Classification:
 AT09-009b

Reference:
 ITB09-032b

7 SPEED A/T HARSH 4>3 DOWNSHIFT ON DECELERATION

Figure 1

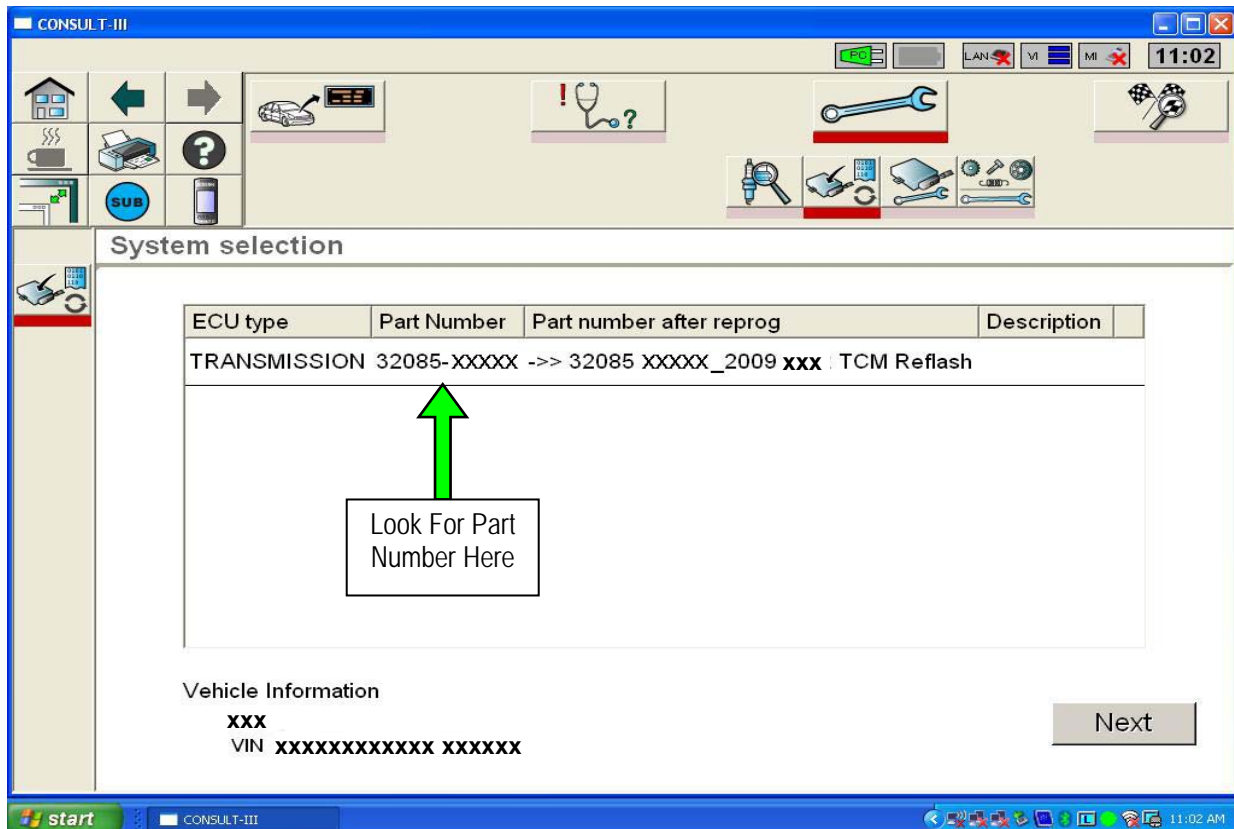
2. When you get to the TCM Reprogramming screen shown in Figure 1, confirm this bulletin applies as follows:
 - A. On your C-III screen, look at the **Part Number** column (see Figure 1 example).
 - If this column is **blank** (no part number listed), this **bulletin does not apply.**
 - If a Part Number (P/N) is listed, write it on the Repair Order and then go to Step B.
